SAM D10 Series Family Silicon Errata and Data Sheet Clarification

The SAM D10 Series family of devices that you have received conform functionally to the current Device Data Sheet (Atmel-42242H-SAM-D10-Datasheet_09/2016), except for the anomalies described in this document.

The following typographic corrections and clarifications are to be noted for the latest version of the Device Data Sheet (Atmel-42242H-SAM-D10-Datasheet_09/2016).

FIGURE 34-2 and 39-2: POR OPERATING PRINCIPLE:

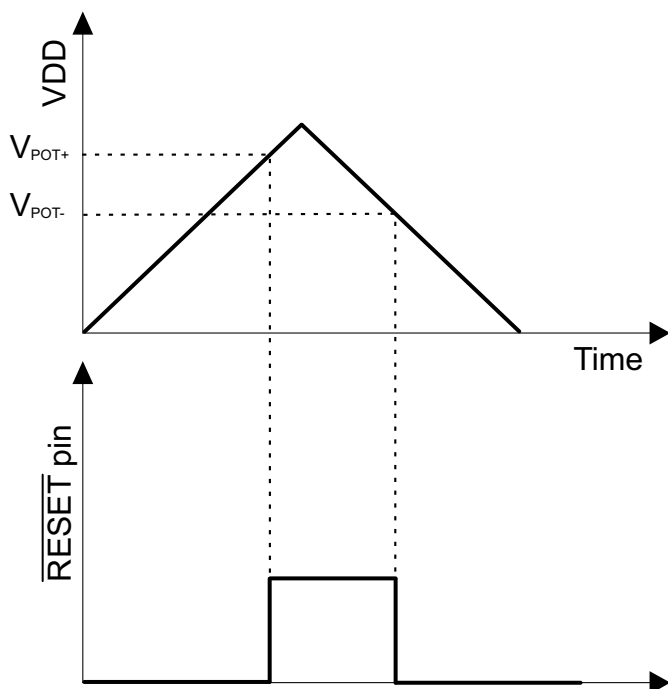
Figures 34-2, 34-3, 34-4, 39-2, 39-3 and 39-4 have an incorrect reset Polarity value. The corrected figures are as shown below:
